City Engineering Department
Ninth Floor Cadillac Tower
Detroit, Michigan 48226

NUCLEAR GAUGE STORAGE AREA

INFORMATION NEEDED FOR NEW LICENSE

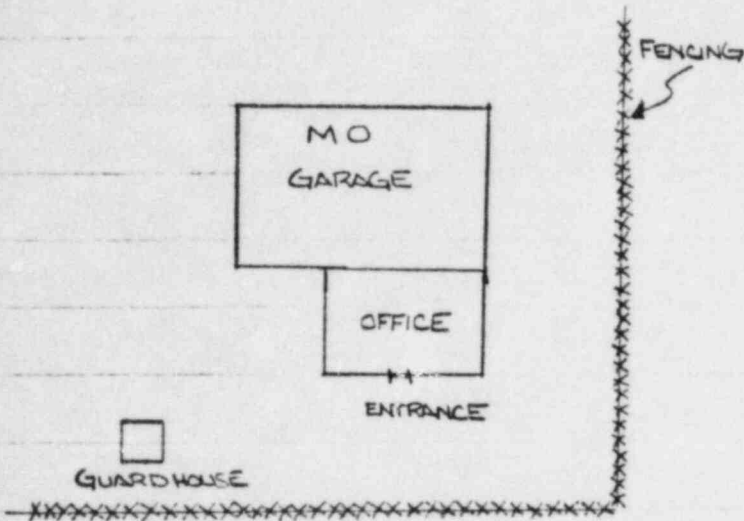
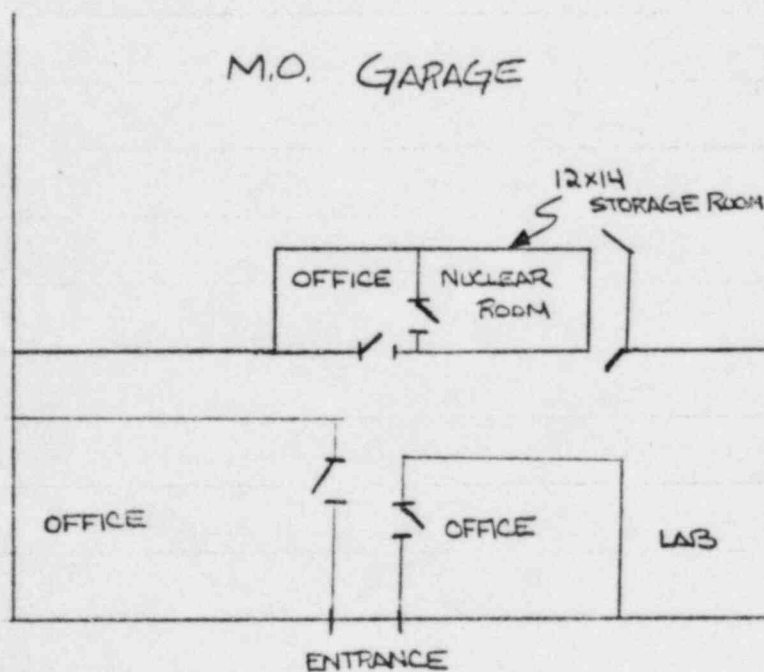
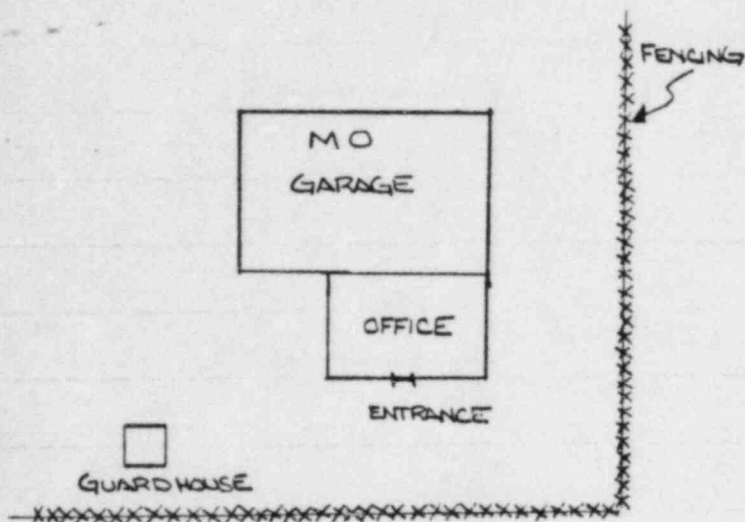
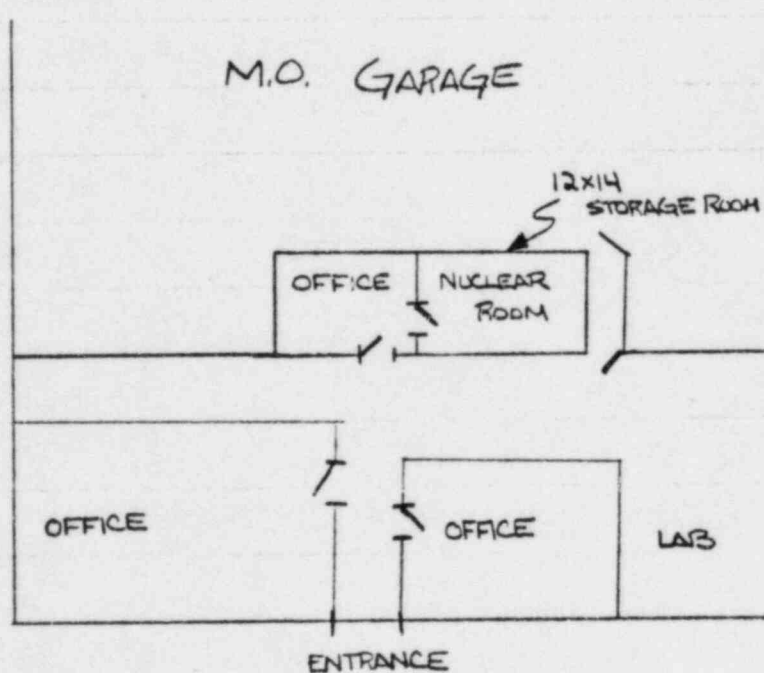
⑤ SKETCH OF STORAGE AREA, AND ADJACENT AREAS. ✓ IS GAUGE STORED IN THE CLOSED POSITION. (CAN CONDITION)

METHOD TO PREVENT REMOVAL.

NUCLEAR ROOM IS
LOCKED AND CAUTION
SIGN POSTED

Storage Area: Room Size 12'w x 14' d
Type of Materials Stored: Troxler Nuclear Density Gauges.
How Stored? In Manufacturer's Cases on Floor.
Rooms Adjacent? Hallway
Office.
Motor Pool Garage.
